# 144 WORCESTER STREET

# 1. ROOF ACCESS + DECK

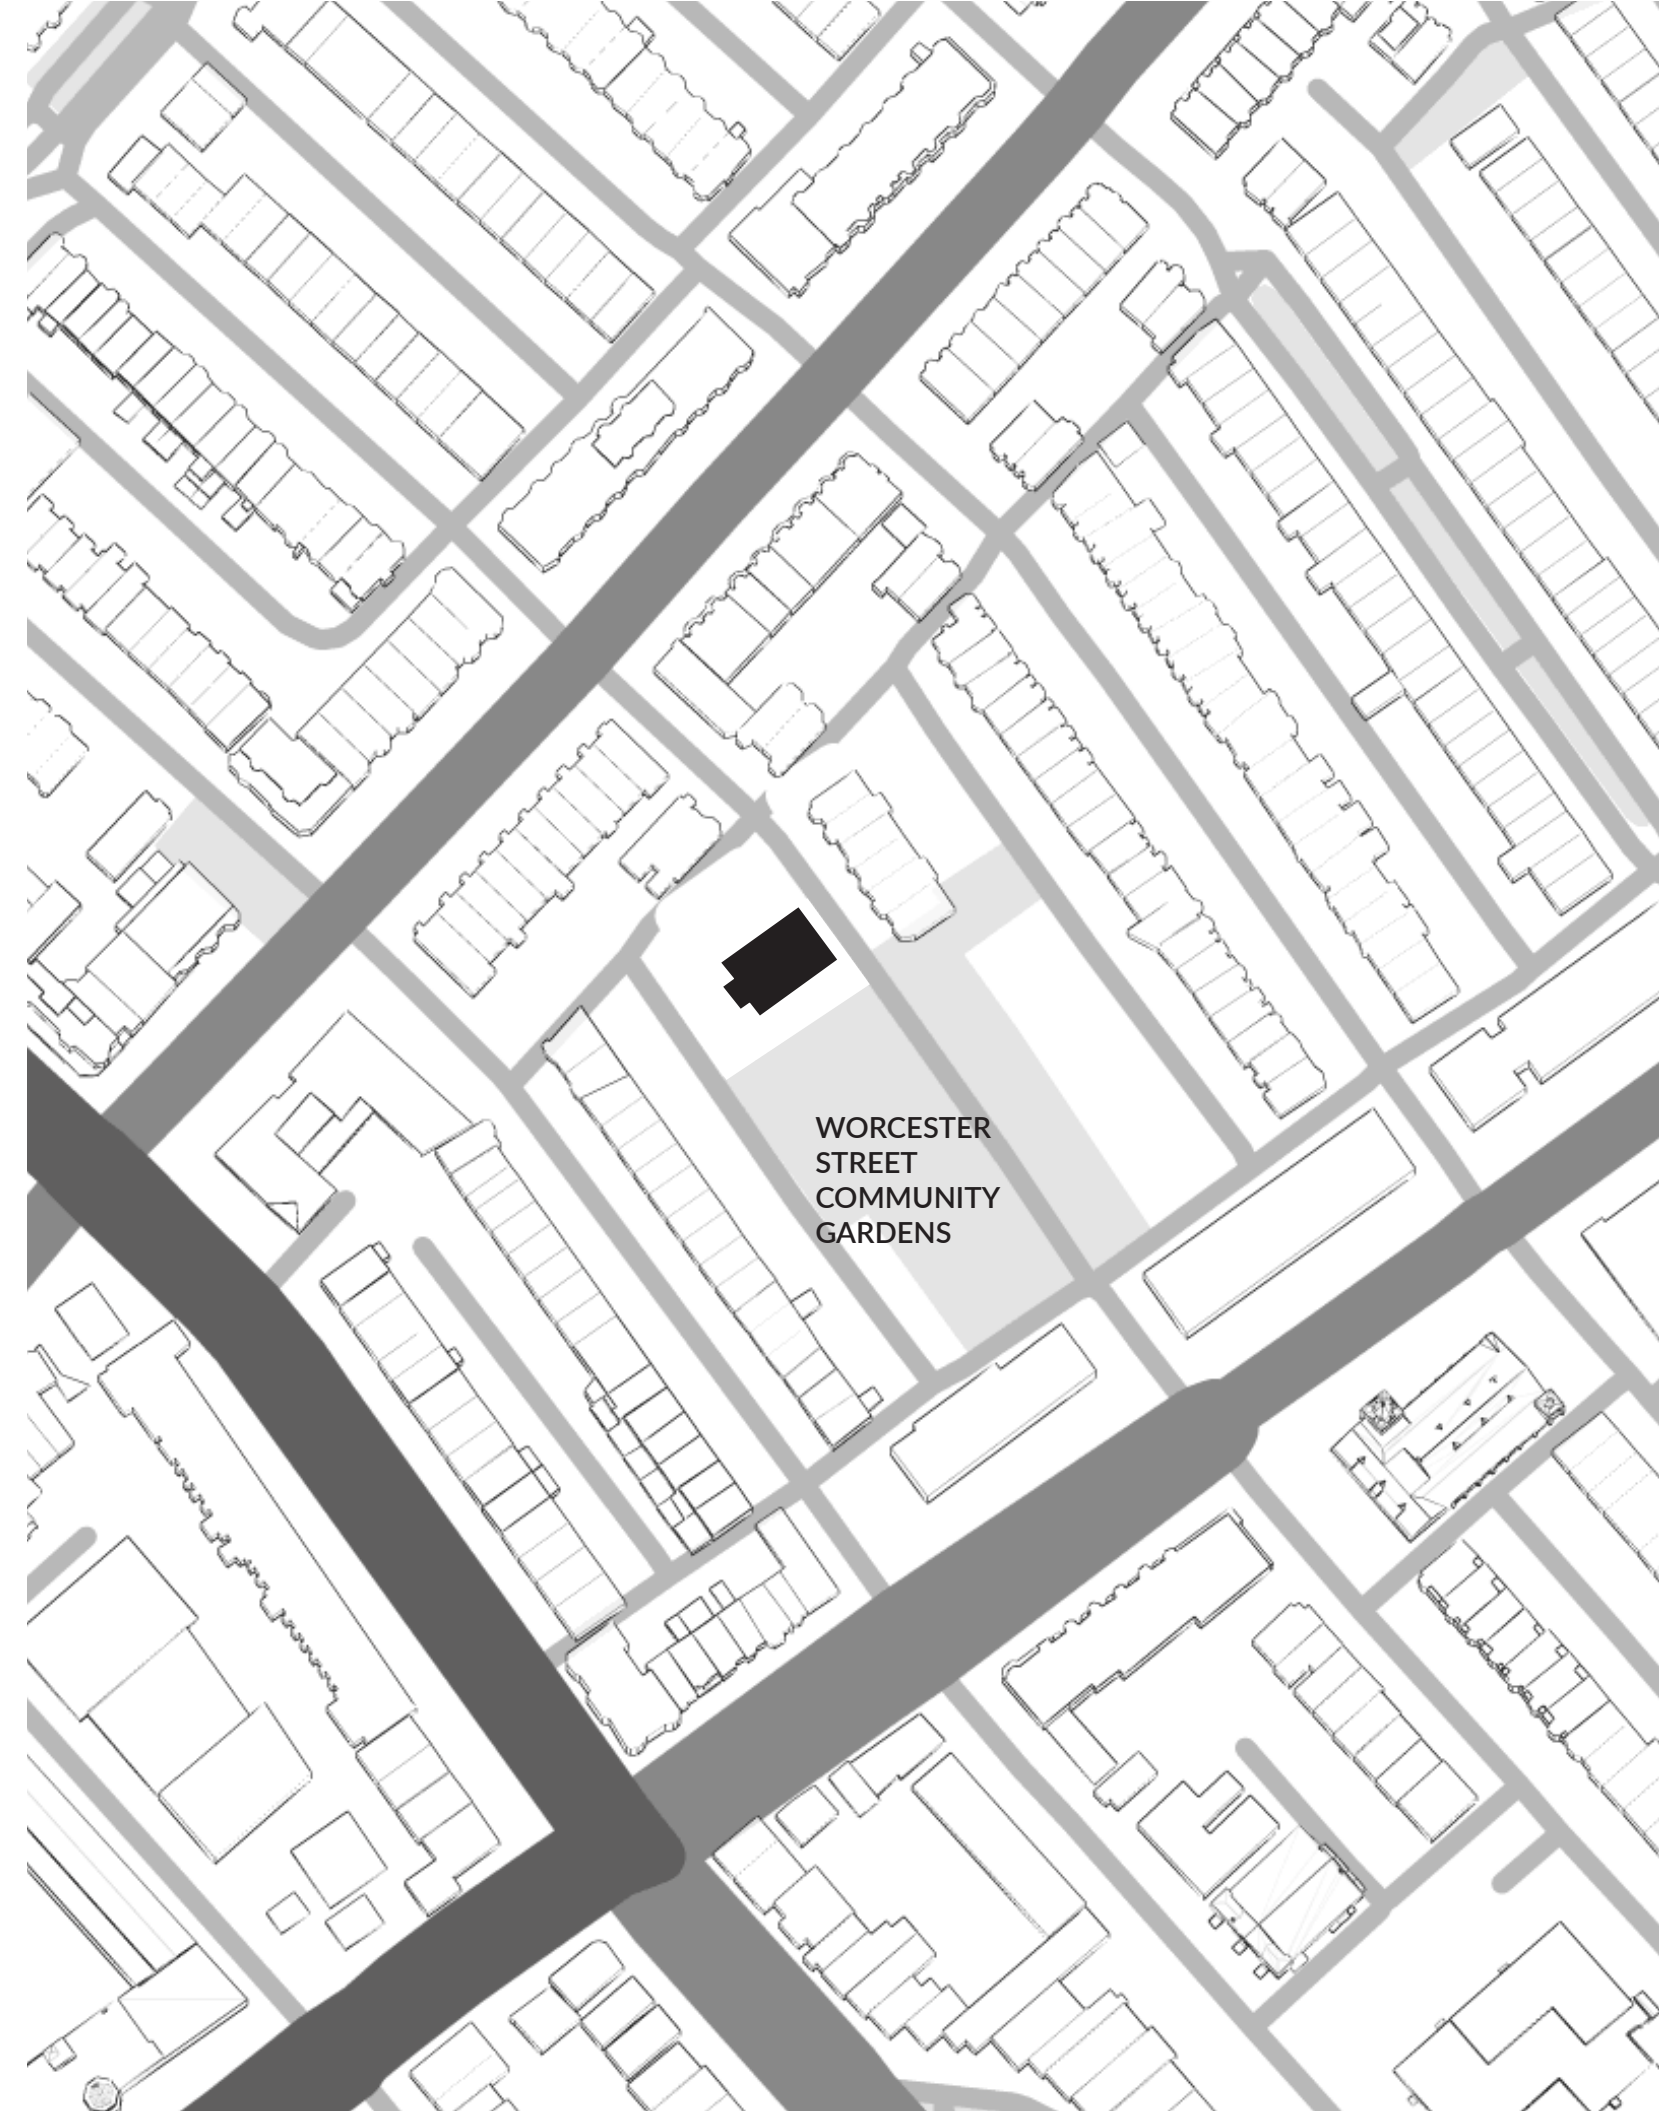
- AS REVIEWED BY LANDMARKS STAFF, IN ACCORDANCE WITH SELDC GUIDELINES, COMMUNITY GARDENS ARE NOT CONSIDERED A PUBLIC WAY
- REAR ALLEY IS NOT A PUBLIC WAY.
- COMMISSION, ABUTTERS AND PROJECT TEAM REVIEWED MOCK-UP ON-SITE DURING SUB-COMMITTEE HEARING ON 05/22.

ROOF DECK RAILINGS WERE DETERMINED TO NOT BE VISIBLE.  
SUB-COMMITTEE REFERED TO ADDITION AS APPROVABLE.

- COMMISSION AND ABUTTERS DISCUSSED POTENTIAL OF GEOMETRY CHANGES  
PROJECT TEAM STUDIED ADJUSTING ROOF LINE ON NORTH SIDE, AND DETERMINED ADDING A SLOPE TO NORTH SIDE ROOF WOULD REQUIRE RAISING ROOF (TO MAINTAIN DESIRABLE HEADHEIGHTS THROUGHOUT) AND WOULD THEREFORE MAKE STRUCTURE MORE VISIBLE. PROJECT TEAM STUDIED SOFTENING WALLS ON NORTH AND SOUTH SIDE, AND FOUND IT NOT FEASIBLE DUE TO CONSTRUCTABILITY CONCERNS. SOUTH SIDE WIDTH CAN NOT BE ALTERED DUE TO CONSTRAINTS SET BY MINIMUM STAIR AND ELEVATOR SHAFT WIDTH.

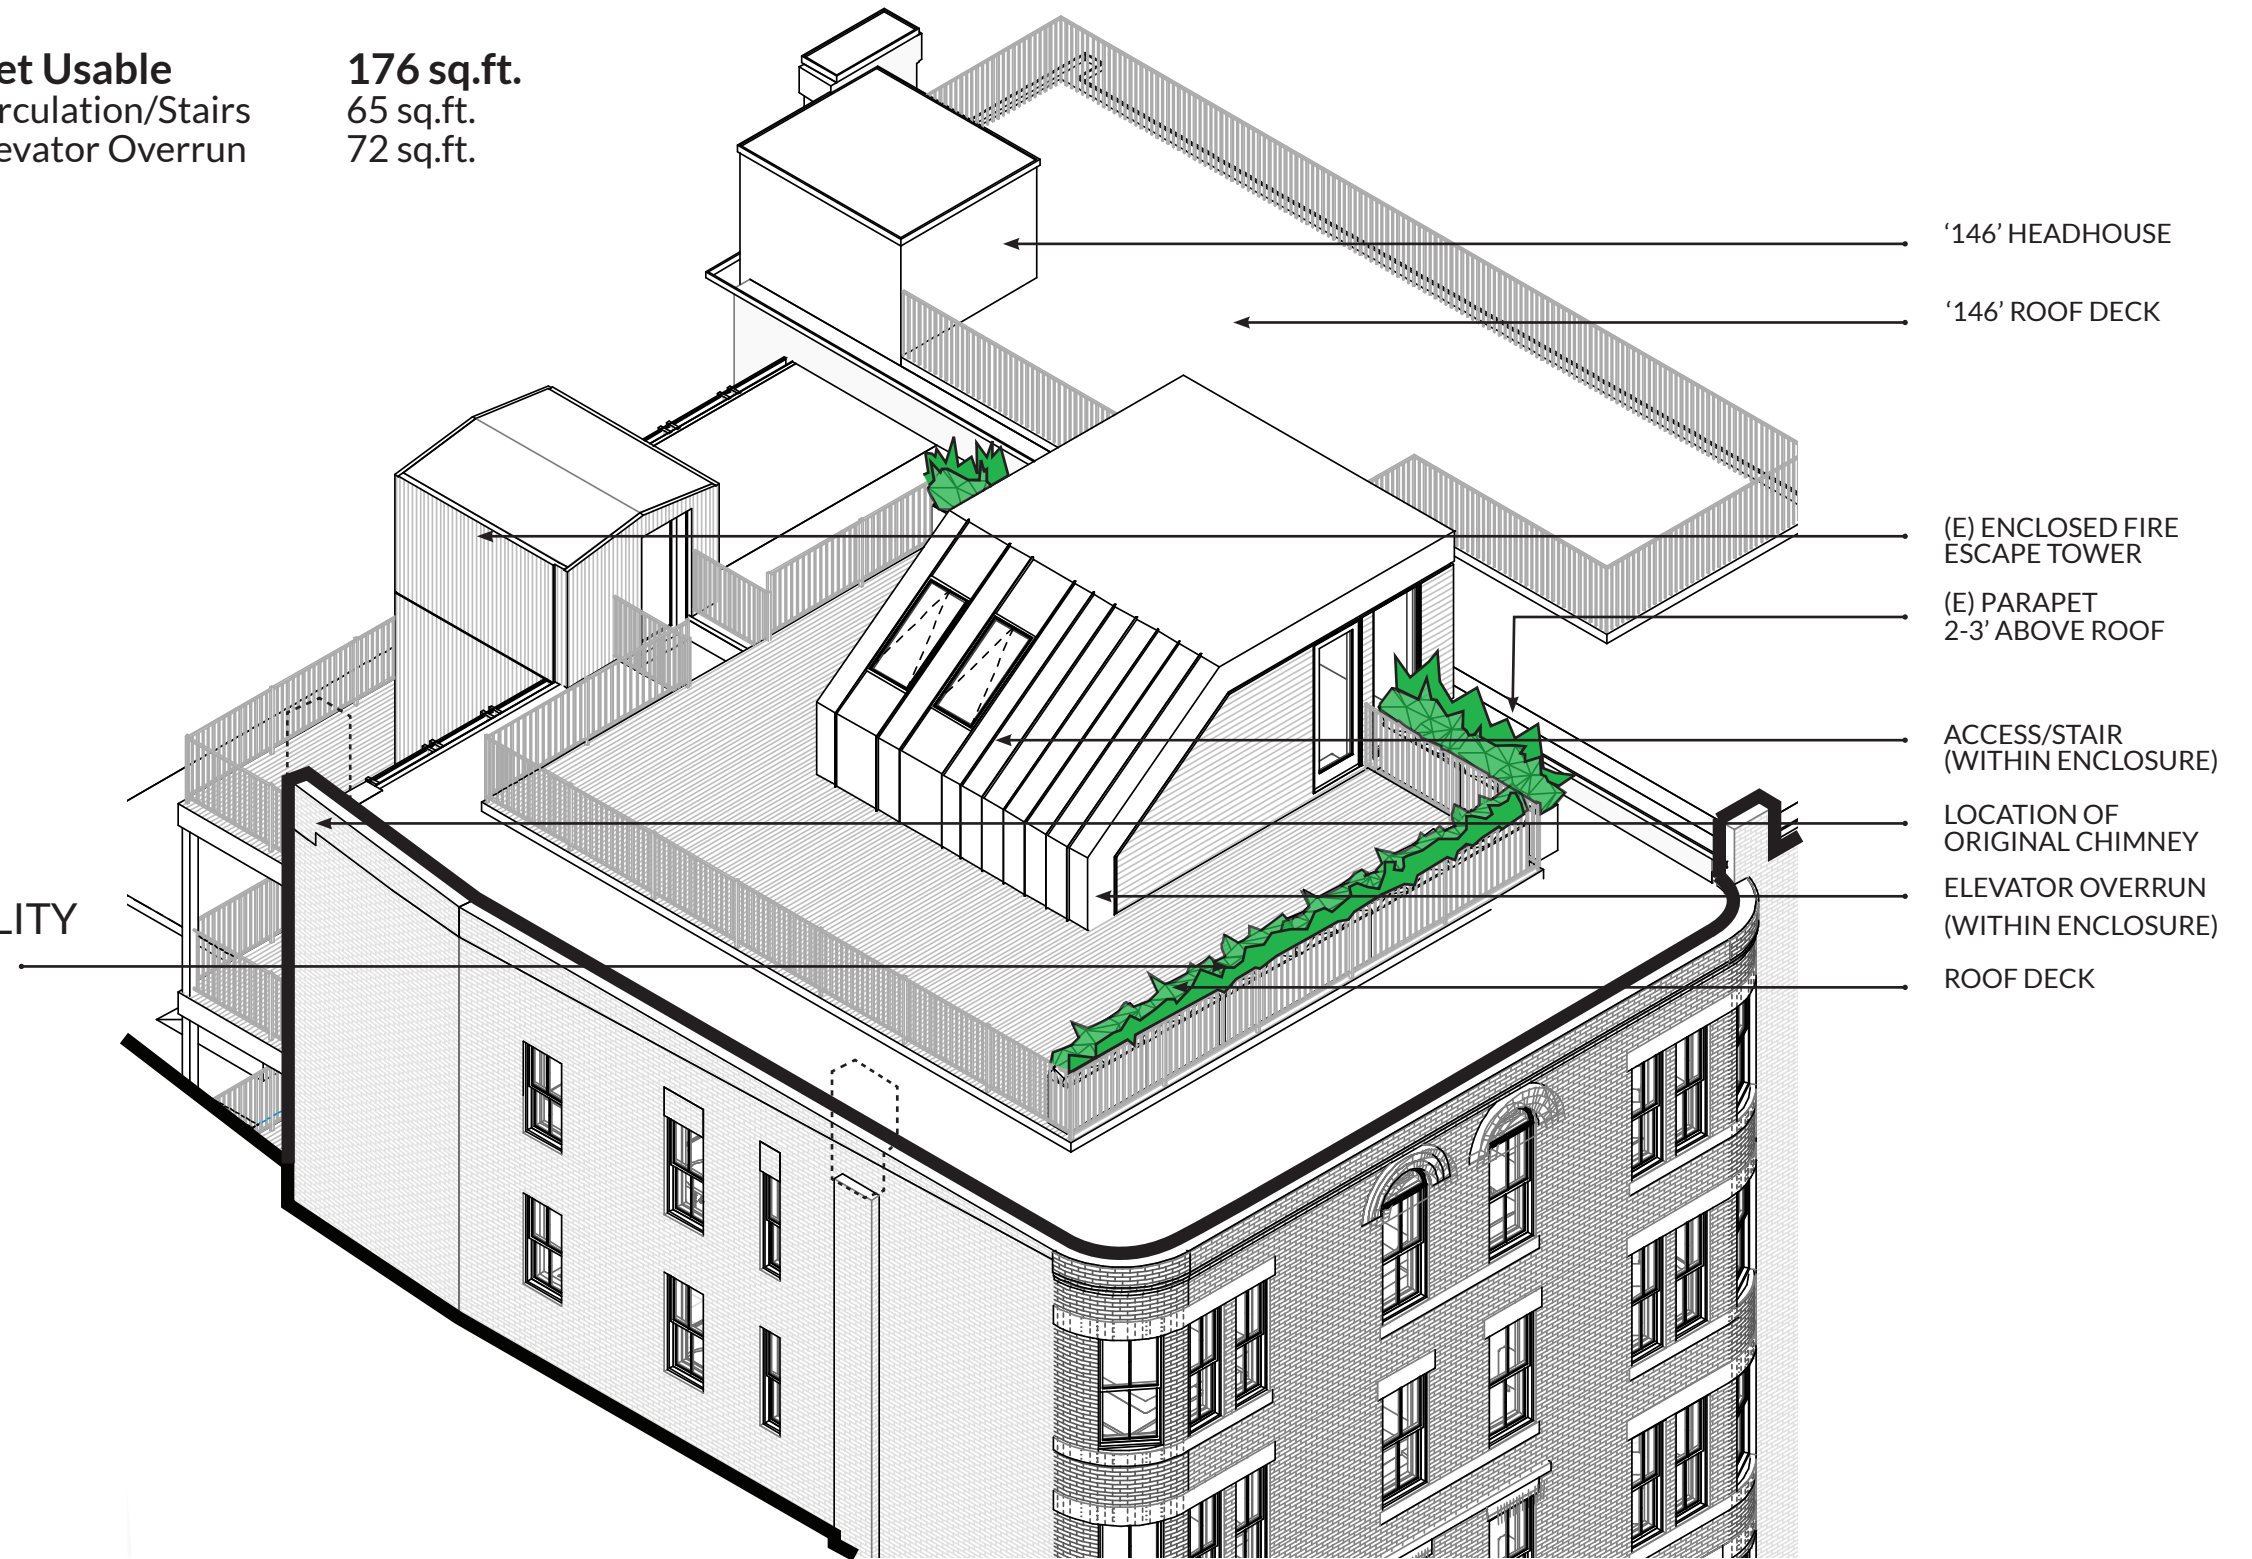
**SUB-COMMITTEE HEARING CONVENED AT VIEWPOINT 2, AT THE SOUTHEAST CORNER OF THE COMMUNITY GARDEN, WHERE IT WAS DETERMINED ROOF DECK RAILINGS WERE NOT VISIBLE AND ADDITION WAS MINIMALLY VISIBLE.**
